Author Response for Submission “PushAround: Collaborative Path Clearing via Physics-Informed Hybrid Search”

Summary of the revision

To Associate Editor

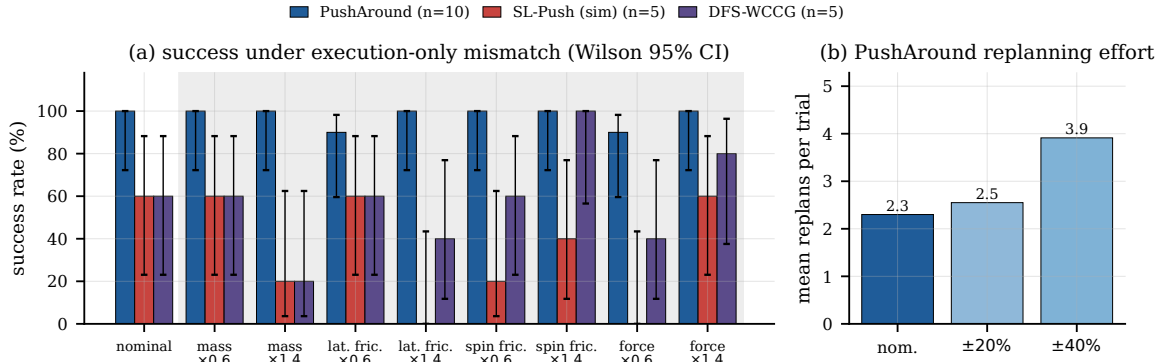
R3.1 Physics-model robustness is insufficiently characterized

Q: *The method relies heavily on simulation-based feasibility validation, but sensitivity to uncertainty in mass, friction, force limits, contact dynamics etc. is not systematically evaluated.*

A: We agree that this was the most substantive gap, because physics validation is the distinguishing element of the method. The original hardware experiments demonstrated closed-loop recovery but did not *isolate* sensitivity to individual model parameters. The revision therefore adds a dedicated planner–execution mismatch study with two properties that make the claim falsifiable:

- **Mismatch, not retuning.** The planner always uses the nominal model; *only* the execution simulator is perturbed. The experiment therefore measures the consequence of an incorrect planning model rather than the benefit of re-identifying it.
- **One family at a time, paired seeds.** Obstacle mass, lateral friction, spinning friction and the robot force limit are scaled separately by $\{0.6, 0.8, 1.2, 1.4\}$, i.e. $\pm 20\%$ and $\pm 40\%$, using the same scene seeds as the nominal condition.

Result. Over 17 conditions ($M=30$, $N=2$, 10 seeds each, 170 trials) PushAround succeeds in **166/170 (97.6%)**, and importantly the success rate does *not* degrade with the perturbation magnitude: **78/80 (97.5%)** at $\pm 20\%$ and **78/80 (97.5%)** at $\pm 40\%$, versus 10/10 nominal. The four failures are one mid-execution planning failure (lateral friction $\times 0.6$) and three trials that exceeded the per-trial budget (spin friction $\times 1.2$, force limit $\times 0.6$ and $\times 1.2$). Replanning absorbs the remainder: mean replans rise from 2.3 (nominal) to 3.9 ($\pm 40\%$ average; up to 8.1 under force limit $\times 0.6$), where the weaker pushing force shortens the reachable force range and lengthens execution from 104.7 s to 159.6 s.

Baseline comparison (added in this revision). To show that this robustness is a property of the method rather than of the scene, we ran SL-Push (sim) and DFS-WCCG under the same protocol

(nominal planning, execution-only perturbation, 5 seeds per condition). Under the identical $\pm 40\%$ perturbations, SL-Push (sim) attains **13/40 (32.5%)** — with 0% under lateral friction $\times 1.4$ and force limit $\times 0.6$ — and DFS-WCCG **23/40 (57.5%)**, while requiring $\sim 12\times$ more planning time (mean 229 s versus 18 s). Both baselines are already weaker at nominal physics (3/5 each versus 10/10), which is consistent with the main comparison in Table II.

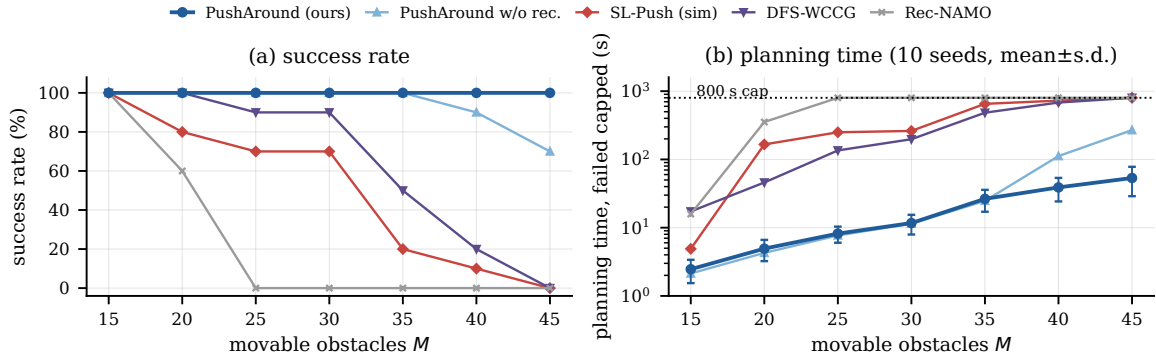
R3.2 Limited number of independent trials

Q: *Although the method is tested with up to 45 movable obstacles, the number of independent trials is limited.*

A: We agree, and we have both increased the number of independent runs and changed how the results are reported.

- **Seeds.** The density sweep now uses **10 independent seed sequences** per density instead of five (7 densities $\times$ 10 seeds = 70 PushAround trials). For each seed the denser instances are

generated incrementally, while different seeds are generated independently, so the success-rate estimates at neighbouring densities are paired but the seeds themselves are not.

- **Dispersion, not only means.** Fig. 9 now shows the success rate and the mean planning time with one-standard-deviation whiskers; Table III lists PT and ET as $\text{mean} \pm \text{s.d.}$. Failed and pruned baseline trials are assigned the 800 s cap before averaging, and the failure composition (plan failure vs. timeout vs. timeout-pruned) is reported per density in the appendix tables.
- **Confidence.** All headline success rates are reported with Wilson 95% intervals in Fig. 5. For PushAround at $M=45$ the interval is $[72.2, 100]\%$ from 10/10; for the baselines at the same density it is $[0, 27.8]\%$ from 0/10.

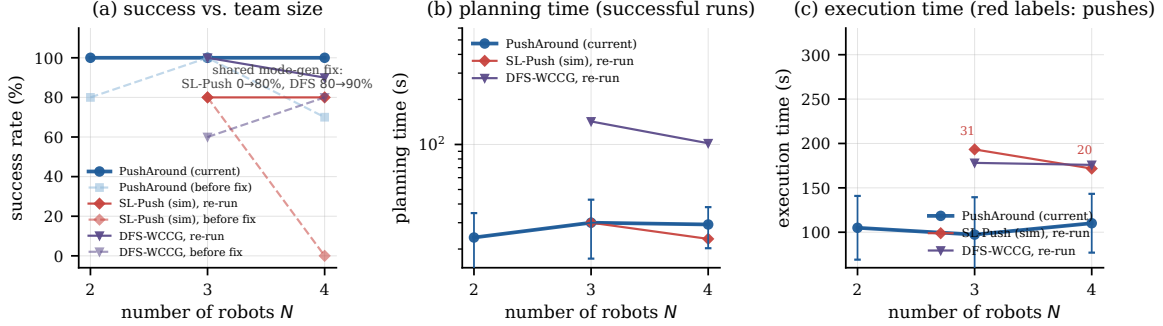
R3.3 Scaling of the search and of the contact/force formulation with team size

Q: *The experiments primarily use two robots. What happens when the number of robots increases with the complexity of the task? How does the search and the contact/force formulation scale to larger robot teams?*

A: This question turned out to be more productive than expected. It exposed a mode-generation bottleneck, we fixed it, and the re-run — performed on *both* PushAround and the baselines with identical code — shows that the fix lives in the shared mode generator rather than being a PushAround-only behaviour. The corrected comparison is reported below.

(a) Complexity. The implementation never enumerates joint contact tuples. With $|\mathcal{A}|$ reachable contact candidates per robot, exhaustive assignment would require $|\mathcal{A}|^N$ tuples; instead one greedy replacement sweep tests at most $N|\mathcal{A}|$ single-contact substitutions, each solving the force LP whose decision vector has dimension $2N$. Larger teams therefore enlarge the feasible wrench set but also increase contact-assignment and LP cost. Sec. III-E2 states this explicitly.

(b) Bottleneck, fix, and who benefits. The preliminary $N=4$ runs failed in 3 of 10 seeds (2 planning failures, 1 budget timeout). Diagnosis: for some push tasks *no* full-team contact assignment exists — small pushable faces, or the pairwise pusher-clearance constraint rejecting every remaining candidate of one robot — and the legacy greedy replacement was additionally sensitive to robot ordering. We added two mode-generation-local refinements that leave global planning, task sampling and the search tree unchanged: (i) *bounded backtracking* contact assignment and (ii) a *temporary per-task robot release* (up to one robot is excluded for that single push and holds its pose, a penalty is charged during mode ranking so full-team modes are preferred, and the full team is re-available for every later task).

Both refinements sit in the shared mode generator, so the baselines inherit them too — which is why the baseline cells were re-run on the same code. Instrumenting the 40 baseline trial logs (4 cells $\times$ 10 seeds) counts 20,890 failed greedy replacements, 10,904 backtracking assignments (rescuing 739 of them) and 6,017 per-task robot releases. The effect is therefore not PushAround-specific:

(c) Revised conclusion. After the fix, all three methods solve 80–100% of the team-size trials, so *we no longer claim that the baselines degrade with team size*, and the success-rate differences at $N=3, 4$ lie within overlapping Wilson intervals (at $N=4$: PushAround $[0.72, 1.00]$, DFS-WCCG $[0.60, 0.98]$, SL-Push (sim) $[0.49, 0.94]$). What remains separated is (i) *consistency*: PushAround is the only method with 30/30 successes over $N=2, 3, 4$; and (ii) *efficiency*: 24–30 s of planning and 97–110 s of execution versus 102–143 s and 172–193 s for DFS-WCCG (whose planning-time standard deviation reaches 183 s at $N=3$), and 10–11 pushes versus 20–31 for SL-Push (sim). The manuscript states this narrower claim rather than a monotone team-size trend.

Figure 4: WCCG validation. (a) Agreement per category: CC and FR differ on 4 of 300 scenes (all raster-unstable), whereas WCCG matches the continuous reference on all 300 with zero false positives/negatives. (b) Mean connectivity-query cost on a logarithmic scale.

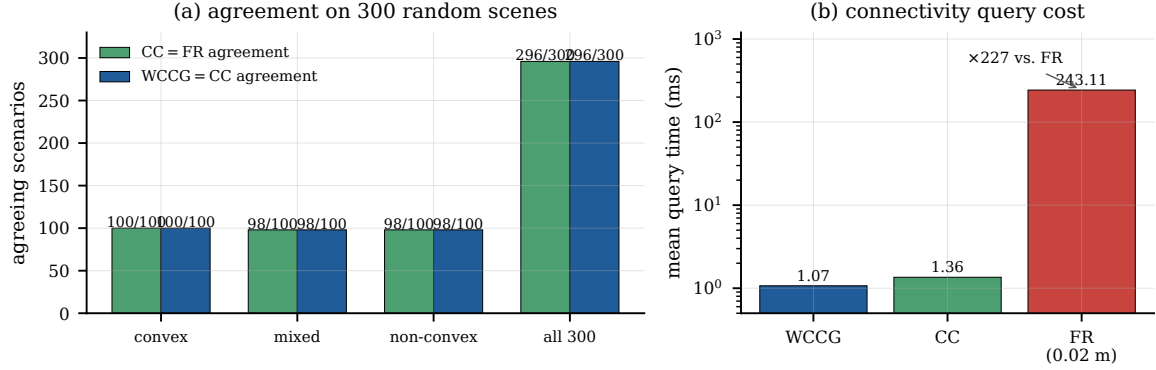
R4.1 WCCG connectivity: justification and C-space comparison

Q: *The WCCG connectivity condition is important since it is used throughout the search and also determines termination ... the paper would benefit from a little more justification here, or perhaps a comparison with a standard configuration-space connectivity check. This seems especially relevant when the obstacles are non-convex.*

A: We agree, and we provide both a derivation and the suggested empirical check.

(a) Why the same-face test is the right query. For a vehicle whose footprint is enclosed by a disk of radius $W/2$, inflating every obstacle boundary by $W/2$ turns any pair of boundary components whose closest distance is below W into *overlapping* barriers in the configuration space of the vehicle centre. A WCCG bridge–bridge edge records exactly such a non-traversable bottleneck, and centroid–bridge edges attach the bottleneck to the adjacent free regions. Consequently, “start and goal lie in the same planar face” is equivalent to connectivity in the complement of the inflated geometry, i.e. to the W -clearance condition. Non-convex obstacles require care, which is why the construction first performs a clearance-relevant convex decomposition and then inserts bridges between the resulting components/segments.

(b) Empirical validation on 300 scenes. Because degenerate geometry and decomposition choices still matter in practice, we also compare WCCG against two independent references on 300 random scenes stratified into convex, mixed, and non-convex obstacles: a continuous configuration-space (CC) reference and a rasterized reference (FR) at 0.02 m, verified at 0.01 m. CC and FR disagree in **4/300** cases, all of which are raster-unstable near narrow or tangential contacts. On all 300 scenes, WCCG agrees with the continuous reference and produces **zero false positives and zero false negatives** — a false positive would be the dangerous case, as it could terminate PIHS prematurely. WCCG additionally answers a query in **1.07 ms** on average, comparable to CC (1.36 ms) and **227×** faster than FR (243.1 ms), while supplying the gap graph that PIHS consumes.

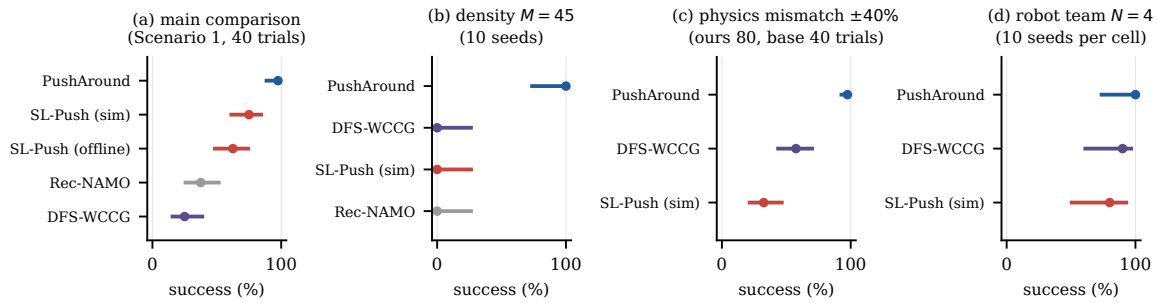
R4.4 Implementation details, budgets, and error bars

Q: *A few more implementation details, such as robot reachability checks, timeout limits, and computation budget, would make the comparison easier to interpret. I would also suggest adding error bars or standard deviations, particularly for the scalability experiment where only five seeds are used for each obstacle density.*

A: We have made the protocol explicit and now report dispersion throughout. The full protocol is summarized in Table 8.

- **(Pages 6–7, Secs. IV-A1 and IV-A6) Statistics.** The density sweep, the robot-team study (all policies) and the mismatch study for PushAround use 10 seeds per cell; only the *mismatch* baseline supplements use 5 seeds and are labelled as such. Fig. 5 reports Wilson 95% intervals for every headline number, and Table III in the manuscript reports $\text{mean} \pm \text{s.d.}$
